# Road Safety Audit Response Report

<b>Report title:</b>	Lye Lane, Bricket Wood, Stage 1 RSA Response
<b>Date:</b>	27/09/22
<b>Document reference and revision:</b>	P2584 Stage 1 RSA Response v1
<b>Prepared by:</b>	Paul Mew Associates
<b>On behalf of:</b>	MRP Planning / JD Rudkin (Builders) Ltd

**Proposed S278 Highway Works**

**Stage 1 Road Safety Audit**

P2584: Land North of Bricket Wood, Herts  
 Proposed Site Access Junction Layout

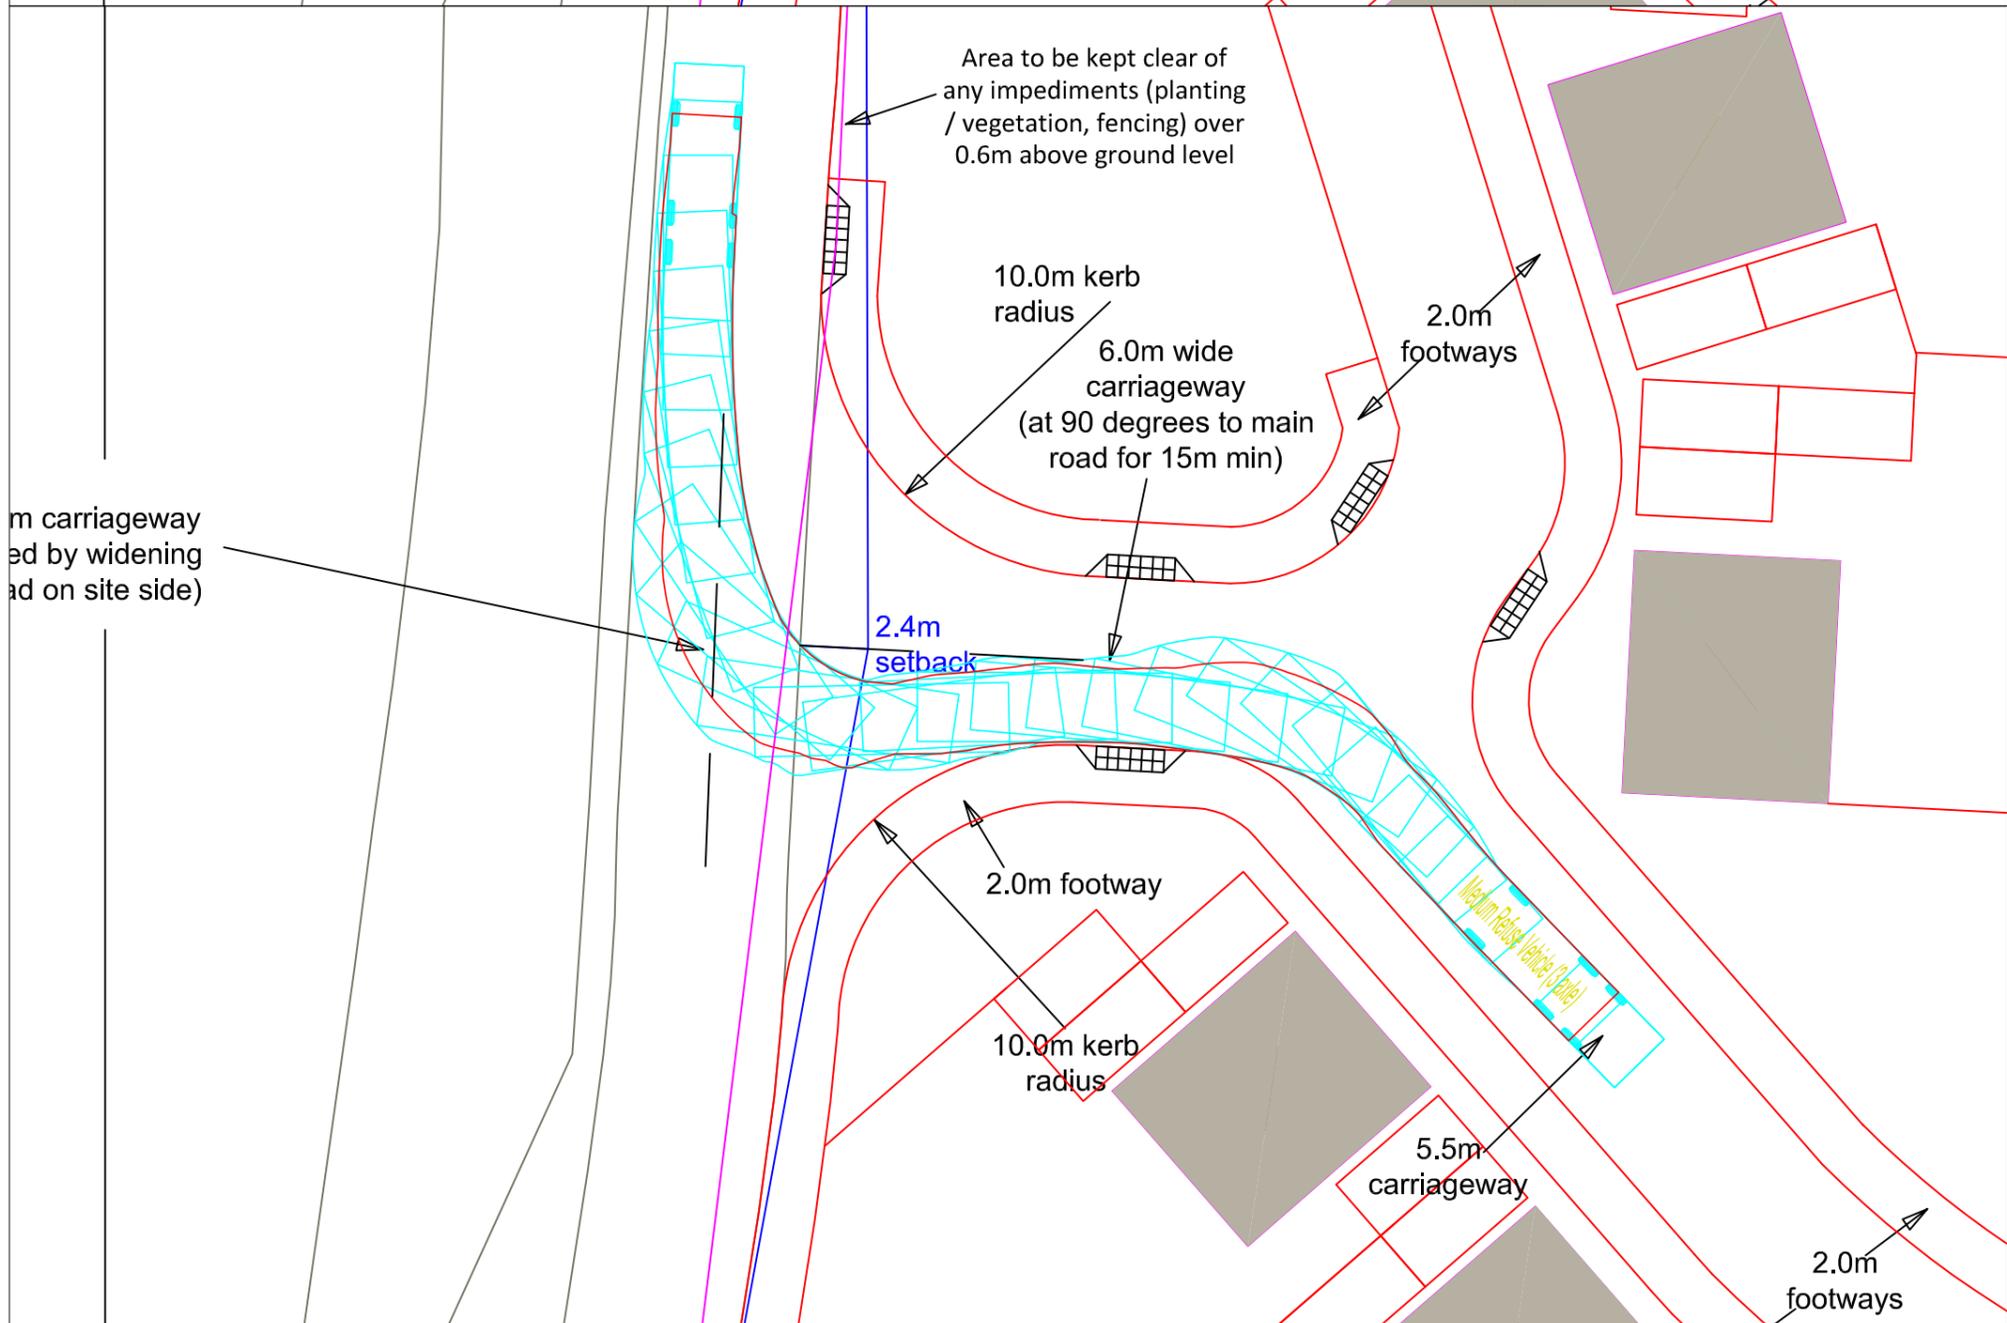
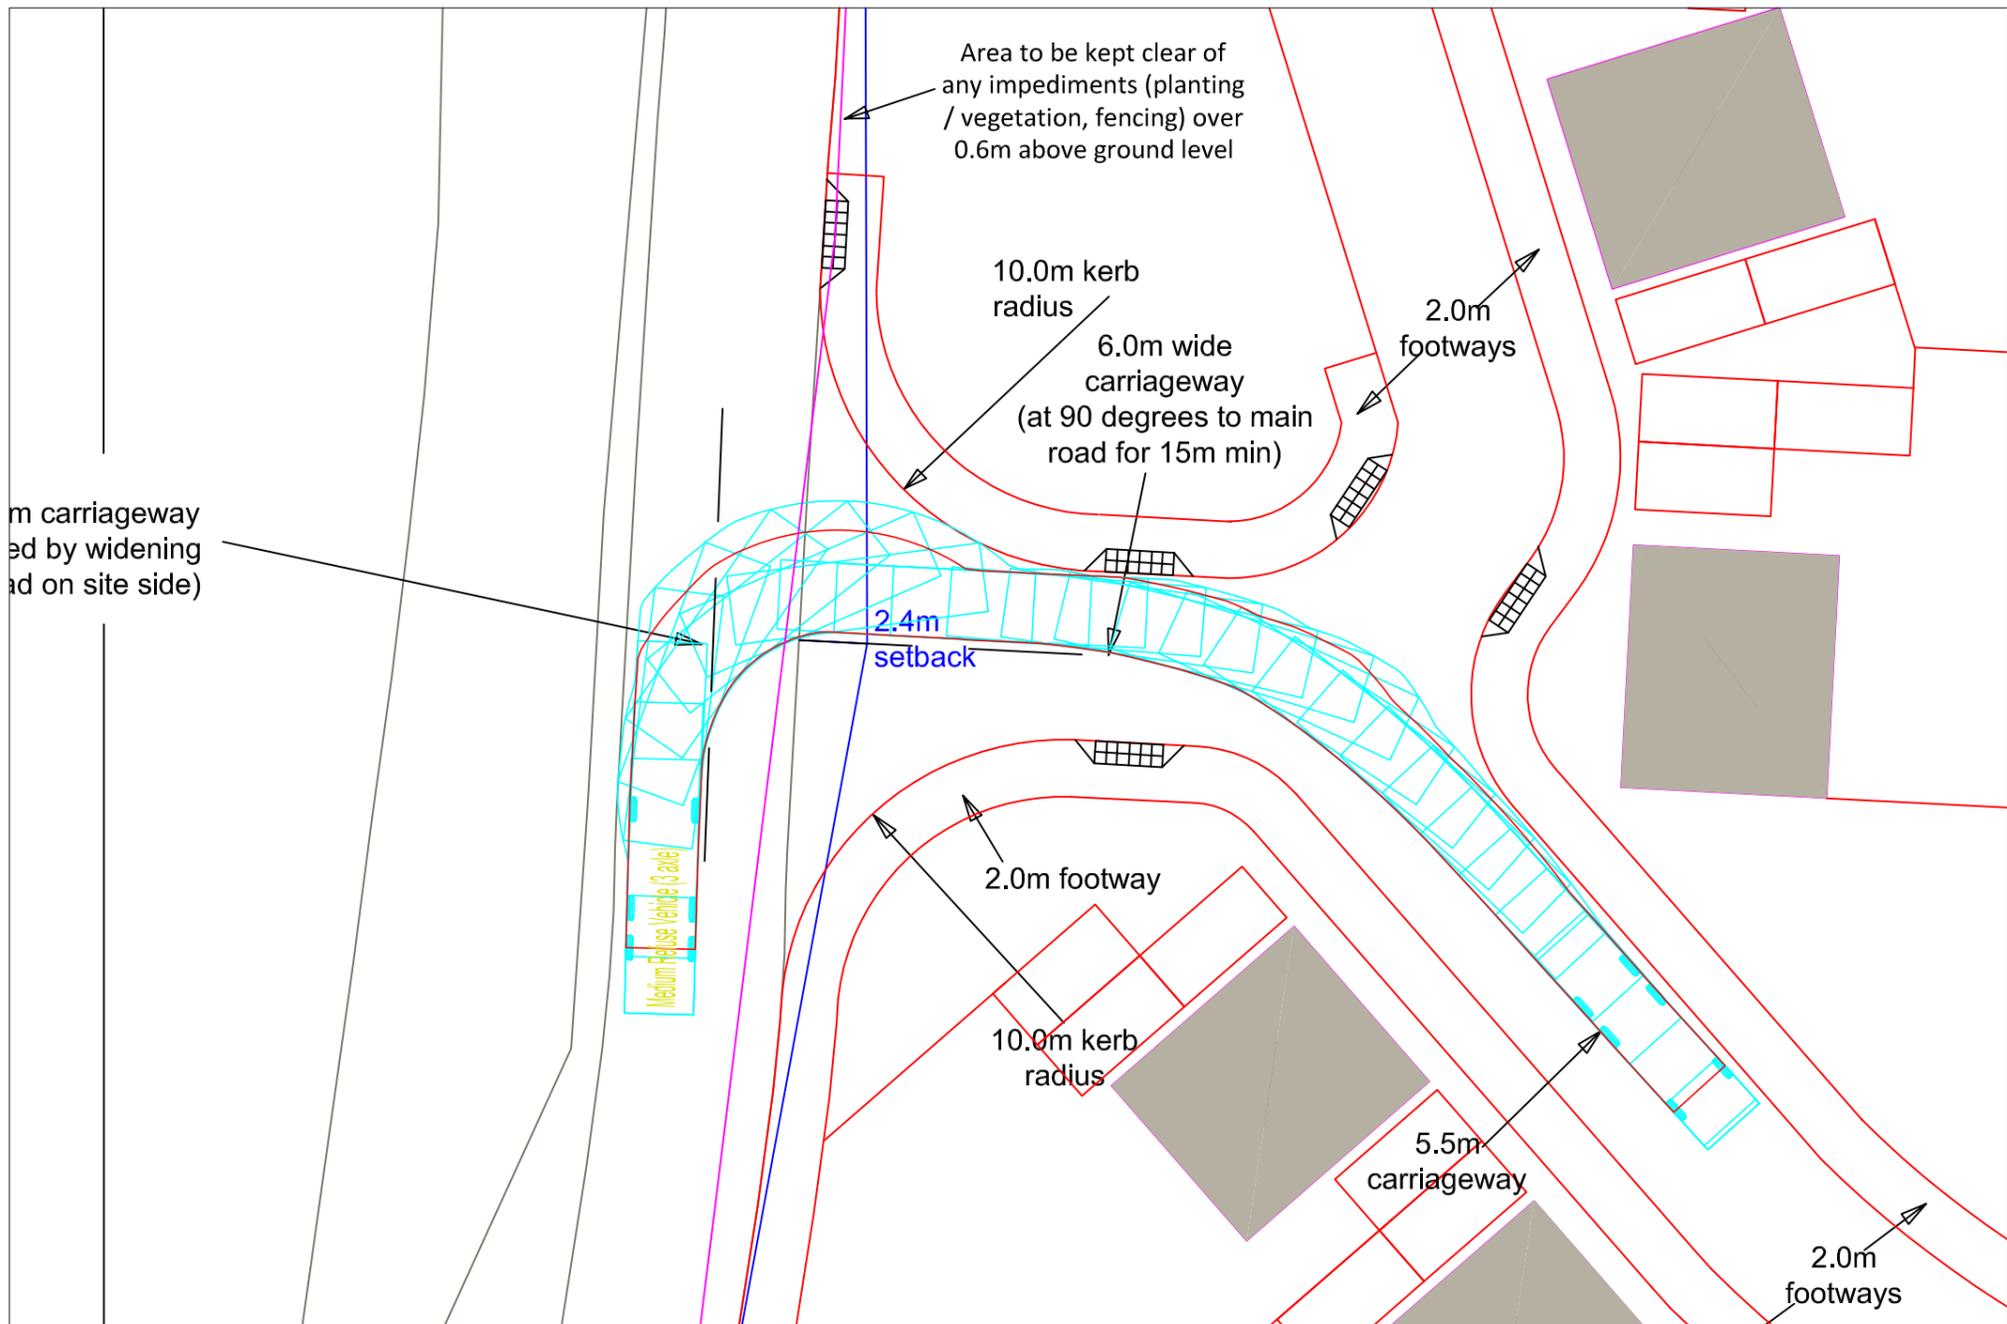
It is recommended that the northern visibility splay should be kept clear of any impediments that may restrict visibility at this location.

Additionally, it is recommended that the proposed visibility splays should be commensurate with the 85<sup>th</sup> percentile speeds on Lye Lane.

It is recommended that dropped kerbs and tactile paving should be provided across the development site access junction, in order to mitigate the above described potential injury scenario.

It is recommended that a length of dropped kerbs should be provided at this location, in order to mitigate the above described potential injury scenario.

It is recommended that the inter-visibility should be accurately measured and kept clear of any impediments that may restrict inter-visibility at this location, in order to mitigate the above described potential collision scenario.

RSA problem	RSA recommendation	Design organisation response	Overseeing Organisation response	Agreed RSA action
<p>Location: A – Lye Lane, development site access junction.            Summary: Potential restricted visibility for motorists seeking to emerge from the development site access junction onto Lye Lane could result in a potential increased risk of side impact collisions occurring, whereby vehicle occupants could sustain personal injury.</p> <p>The scheme drawing indicates the provision of a new access junction on the eastern side of Lye Lane, located to the north of the existing vehicular access for the paintball centre. The existing vehicular access is to be stopped up. The site visit has established that the posted speed limit on Lye Lane was 30mph, as indicated by repeater signs on posts.</p> <p>The recorded 85th percentile speeds on Lye Lane were 31.2mph for northbound vehicular traffic and 32.2mph for southbound vehicular traffic.</p> <p>It is evident from the scheme drawing that the 2.4m x 43m visibility splay to the north of the proposed development site access junction crosses the development site frontage denoted in green.</p> <p>Concern arises that potential landscaping / fencing fronting the proposed development site could restrict visibility for motorists emerging from the development site access junction onto Lye Lane. The situation could be exacerbated as the 85th percentile speeds are slightly higher than the posted 30mph speed limit and the provision of 43m visibility splays. As a result, restricted visibility could lead to a potential increased risk of side impact collisions occurring, between vehicular traffic emerging from the development site and vehicular traffic on Lye Lane, whereby vehicle occupants could sustain personal injury</p>	<p>It is recommended that the northern visibility splay should be kept clear of any impediments that may restrict visibility at this location.</p> <p>Additionally, it is recommended that the proposed visibility splays should be commensurate with the 85th percentile speeds on Lye Lane.</p>	<p>The northern visibility splay will be kept clear of any impediments (planting / vegetation, fencing) over 0.6m above ground level that may restrict visibility at this location. Sightlines have been amended to show requirements based on 85<sup>th</sup> %ile recorded speeds of 31.2mph NB – sightline requirement of 45m and 32.2mph SB – sightline requirement of 47m. Revised drawings are shown in Appendix B.</p>

<p>Locations: C, D and E – Development site access junction.</p> <p>Summary: Lack of dropped kerbs could result in a potential increased risk of pedestrian trips and falls occurring on the assumed full height kerb upstands, whereby pedestrians could sustain personal injury, especially those who are blind, visually or mobility impaired.</p> <p>The scheme drawing indicates the provision of a new access junction on the eastern side of Lye Lane. The scheme drawing also indicates the provision of footways leading from the proposed development site onto the new footway provision on the eastern side of Lye Lane.</p> <p>Within the proposed development site, the scheme drawing indicates that the proposed footways either side of the development site access road end, resulting in pedestrians either crossing to the opposite footway or</p>	<p>It is recommended that dropped kerbs and tactile paving should be provided across the development site access junction, in order to mitigate the above described potential injury scenario.</p> <p>Additionally, it is recommended that uncontrolled pedestrian crossing facilities should be provided within the proposed development</p>	<p>Dropped kerbs / tactile paving / uncontrolled pedestrian crossing facilities have been introduced at various locations within the proposed development site. Revised drawings are shown in Appendix B</p>

<p>Location: F – Footway to the north of the development site access junction.</p> <p>Summary: Lack of dropped kerbs could result in a potential increased risk of pedestrian trips and falls occurring on the assumed full height kerb upstands, whereby pedestrians could sustain personal injury, especially those who are blind, visually or mobility impaired.</p> <p>The scheme drawing indicates the provision of a new access junction on the eastern side of Lye Lane. The scheme drawing also indicates the provision of footways leading from the proposed development site onto the new footway provision on the eastern side of Lye Lane.</p> <p>Concern arises that pedestrians negotiating the assumed full height kerb upstands when transitioning between the footway and carriageway to the north of the proposed development site access junction, could lead to a potential increased risk of pedestrian trips and falls occurring, whereby pedestrians could sustain personal injury, especially those who may be blind, visually or mobility impaired.</p>	<p>It is recommended that a length of dropped kerbs should be provided at this location, in order to mitigate the above described potential injury scenario.</p>	<p>A dropped kerb with tactile paving will be provided at this location. Revised drawings are shown in Appendix B</p>

<p>Location: G – Footway to the north of the development site access junction.</p> <p>Summary: Potential restricted inter-visibility for</p>	<p>It is recommended that the inter-visibility should be accurately measured</p>	<p>Intervisibility splay will be kept clear of any impediments (planting / vegetation, fencing) over 0.6m above ground level that may restrict visibility at this location.</p>

<p>pedestrians transitioning from the footway to the carriageway could result in a potential increased risk of vehicle and pedestrian collisions occurring, whereby pedestrians could sustain personal injury. The scheme drawing indicates the provision of a new access junction on the eastern side of Lye Lane. The scheme drawing also indicates the provision of footways leading from the proposed development site onto the new footway provision on the eastern side of Lye Lane.</p> <p>It is evident from the scheme drawing that the proposed footway to the north of the development site access junction ends adjacent to the development site frontage denoted in green.</p> <p>Concern arises that potential landscaping / fencing fronting the proposed development site could restrict inter-visibility between pedestrians transitioning between the footway and carriageway when walking northbound on Lye Lane and southbound vehicular traffic. As a result, this situation could lead to a potential increased risk of vehicular and pedestrian collisions occurring, whereby pedestrians could sustain personal injury.</p>	<p>and kept clear of any impediments that may restrict inter-visibility at this location, in order to mitigate the above described potential collision scenario.</p>	<p>Pedestrian – vehicle intervisibilities of 65m (in line with 85<sup>th</sup> %ile speeds) can be achieved and are shown in the Revised drawings in Appendix B.</p>
